PROJECT ADDENDUM #1

30 JULY 2026

PROJECT: Multiple Buildings Elevator Modernization
Middle Tennessee State University
SBC Project No. 366/009-05-2021A

C2.1 Elevator # 1 Plans

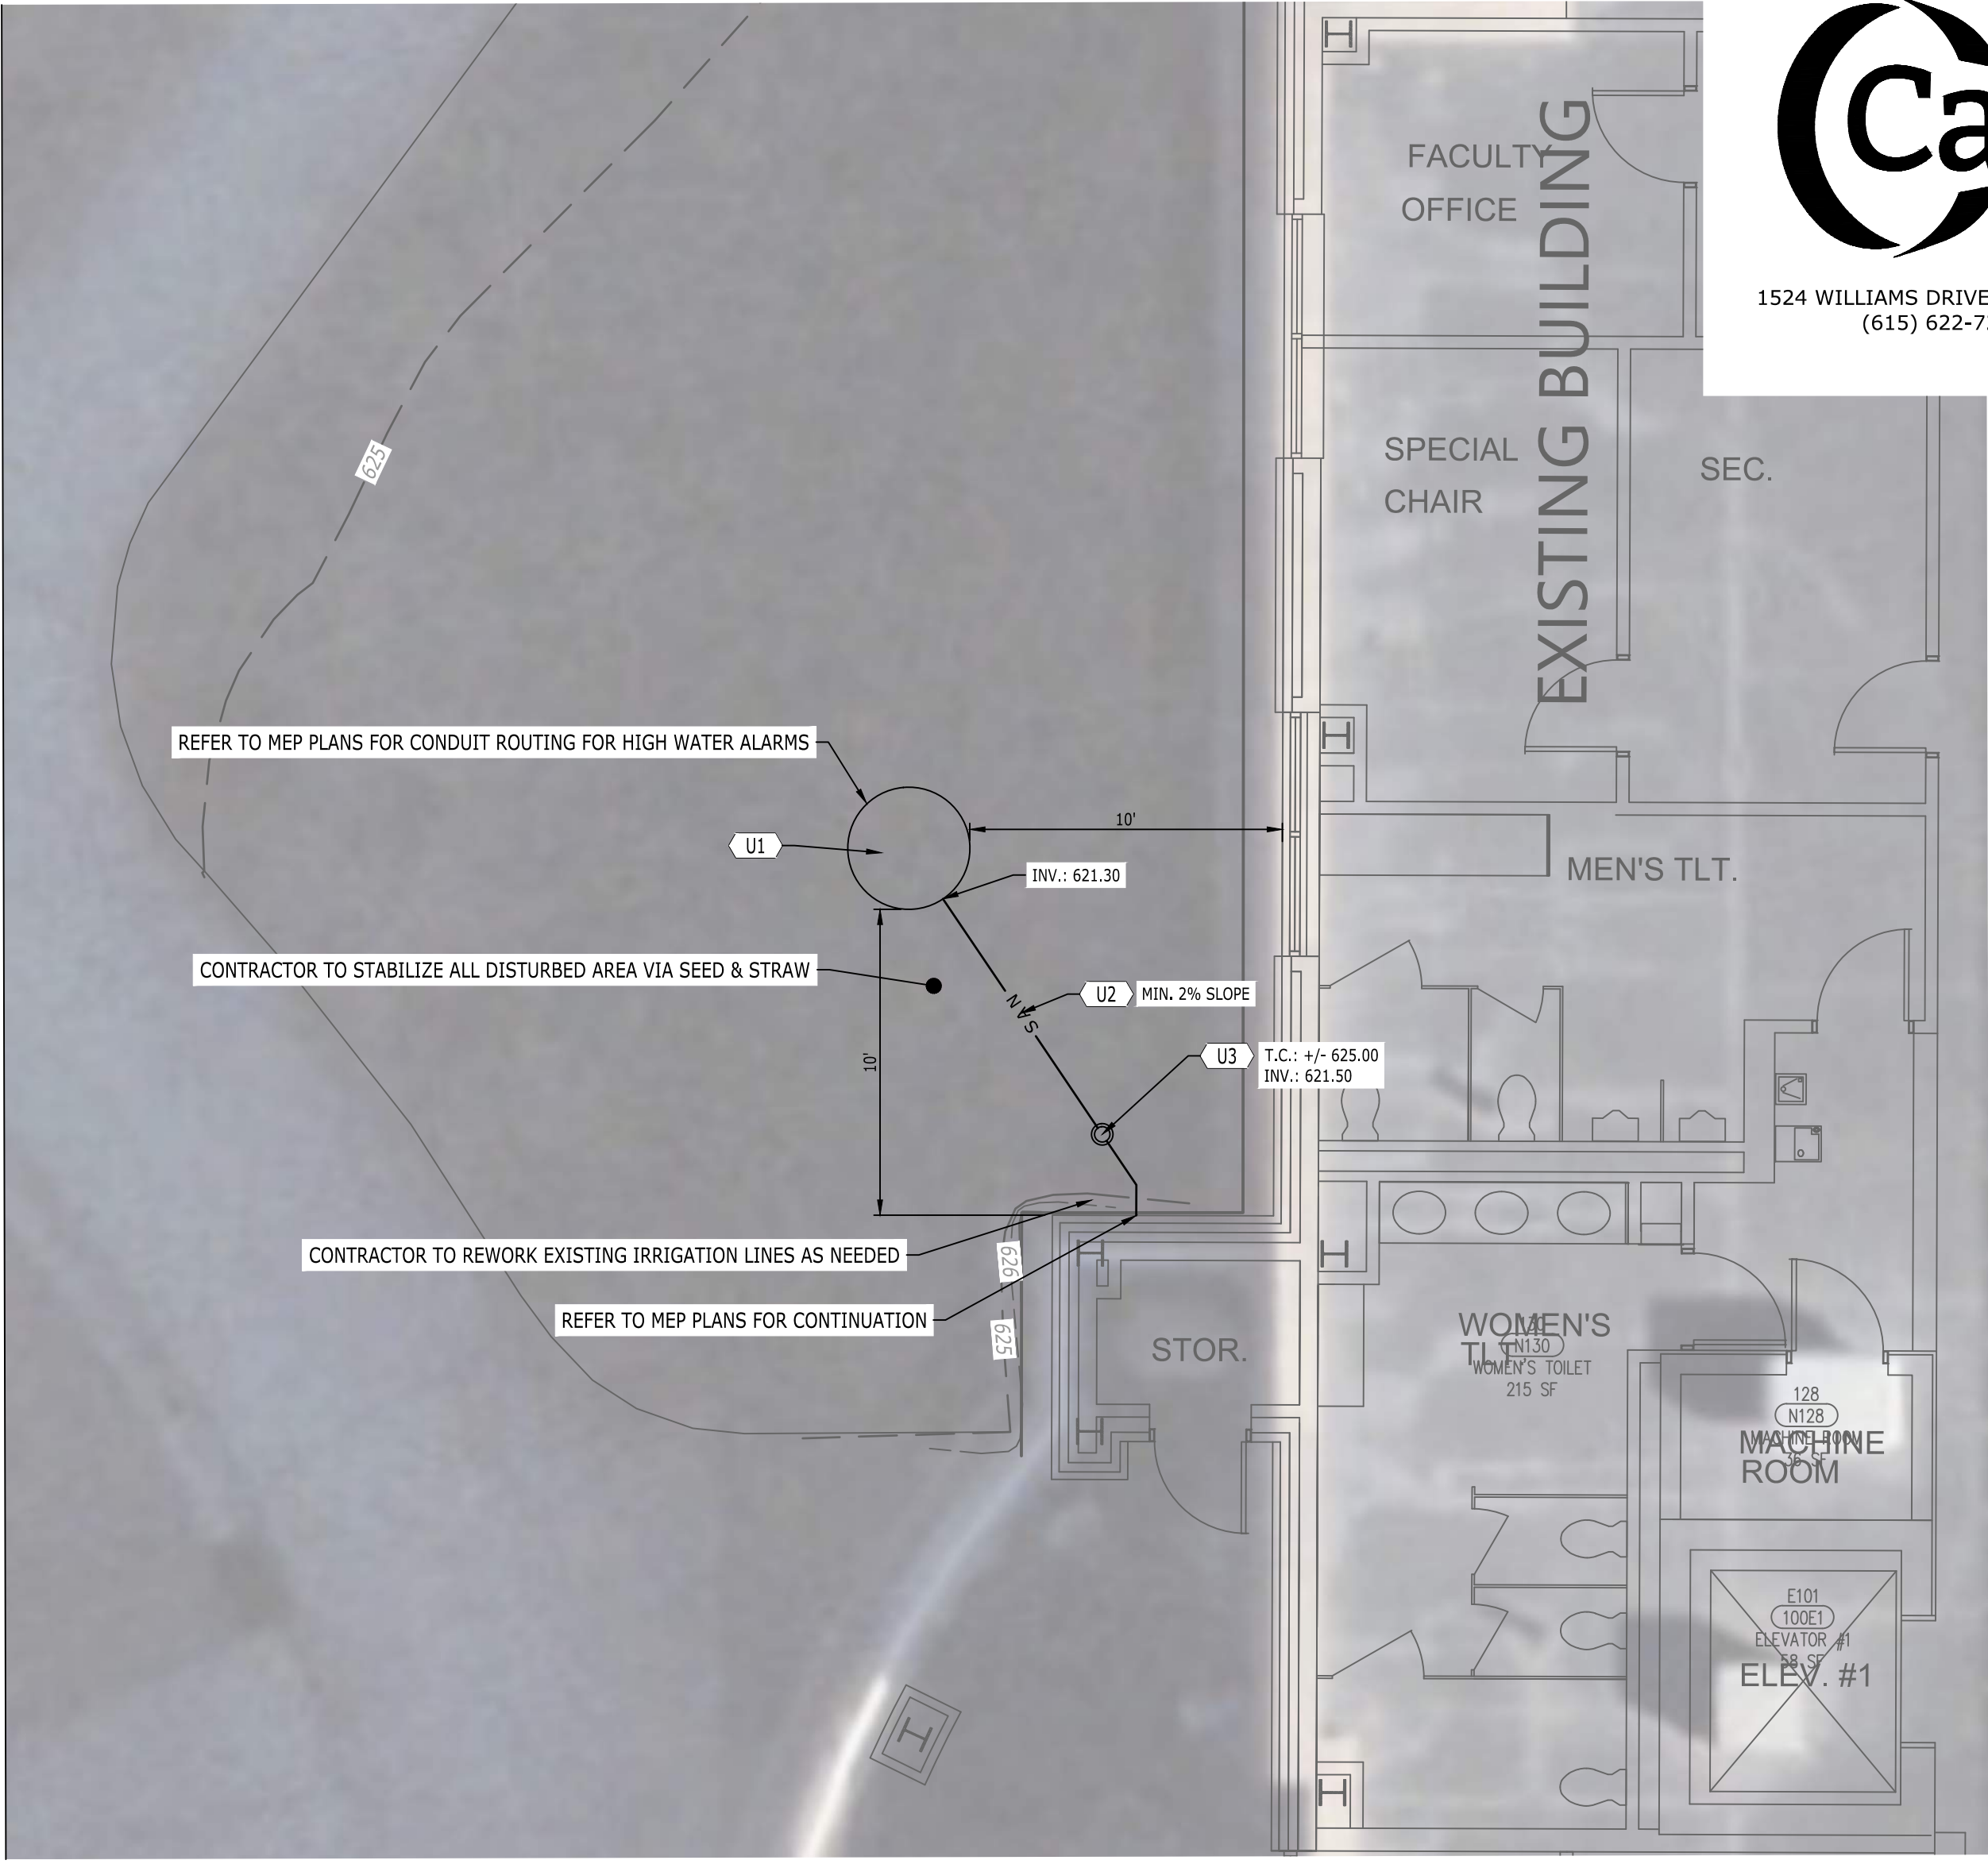
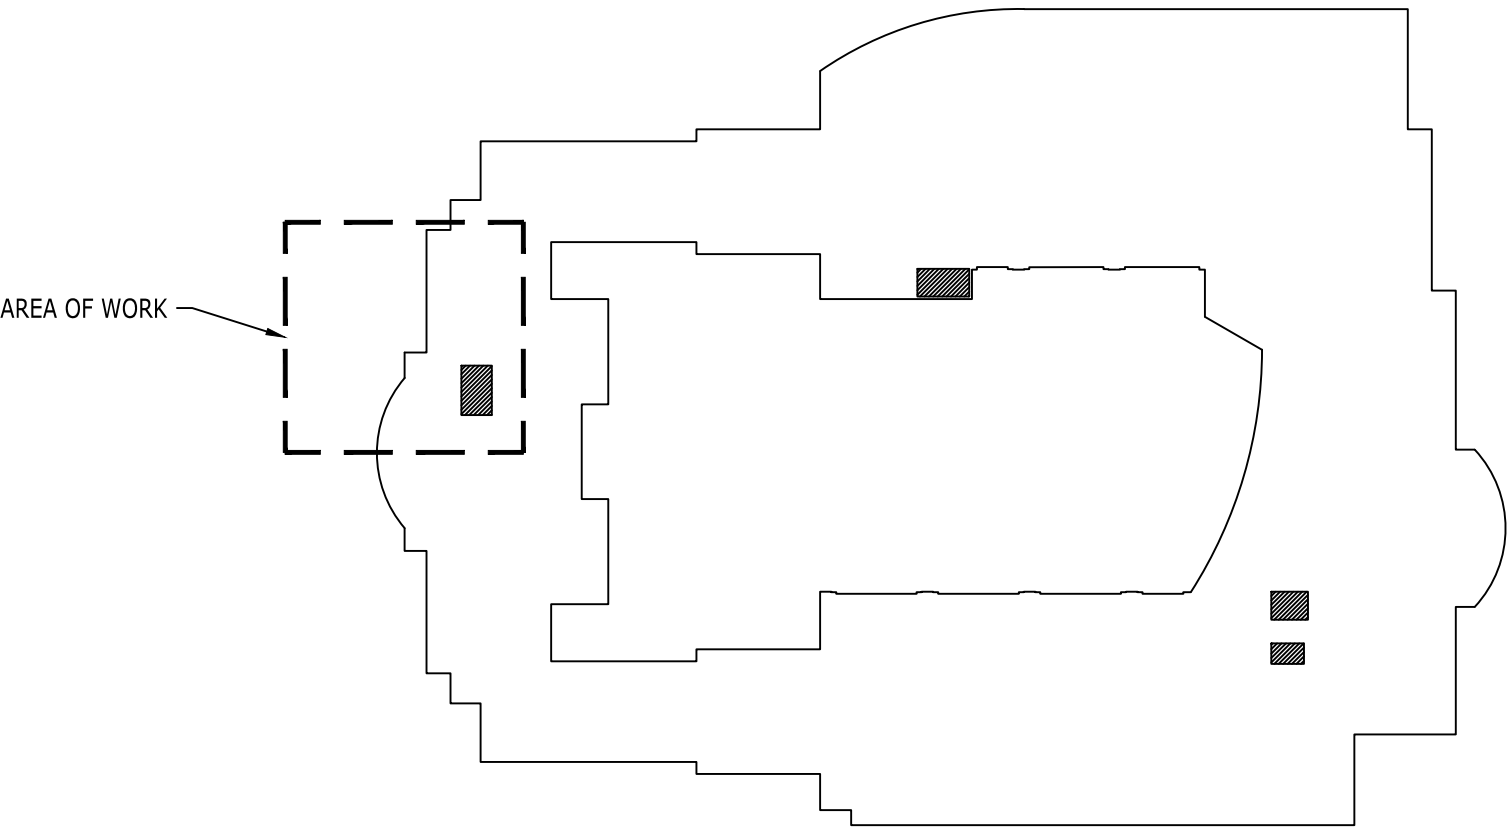
Utility Keynotes: U2 - Change sanitary sewer line size to 4" PVC.

C2.2 Elevator # 2 Plans

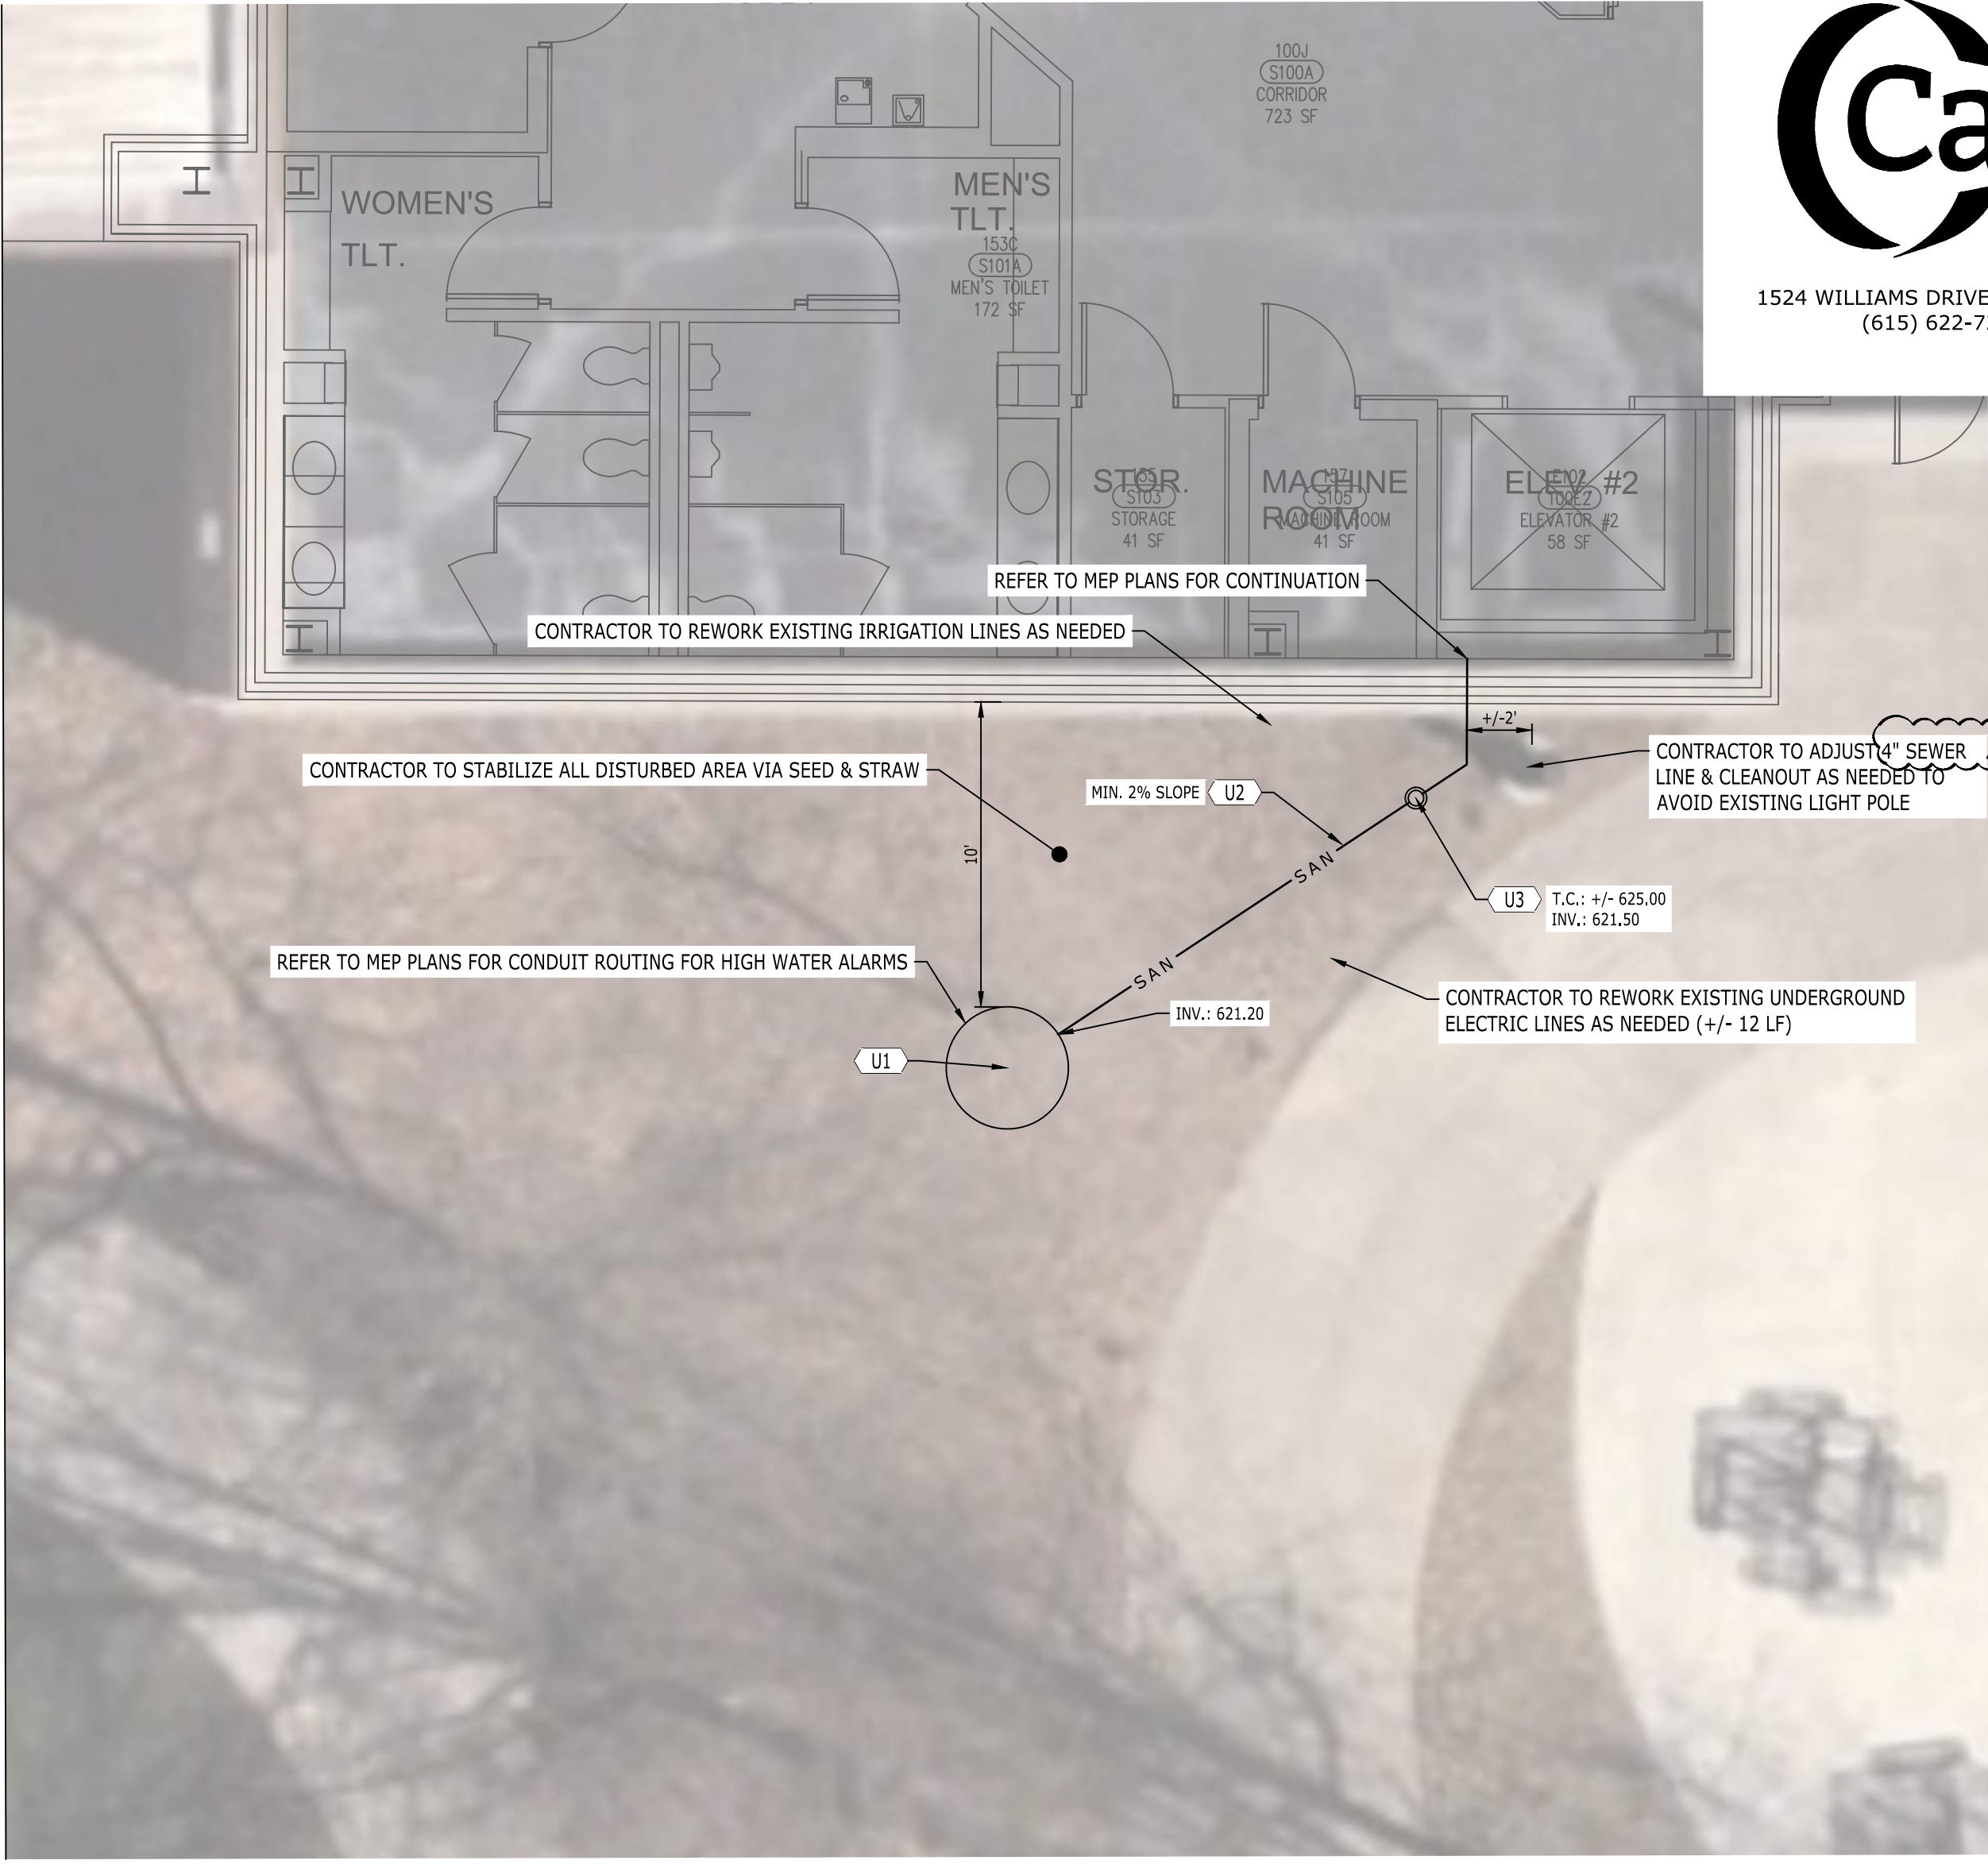
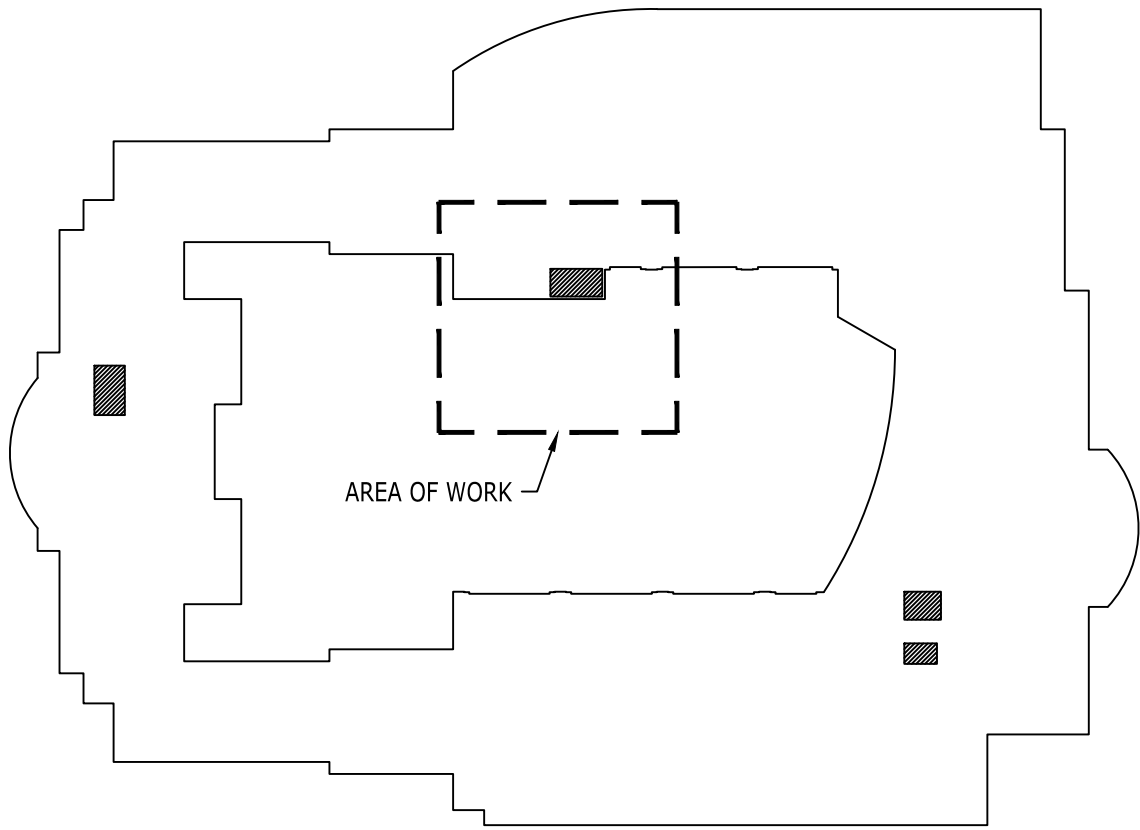
Utility Keynotes: U2 - Change sanitary sewer line size to 4" PVC.
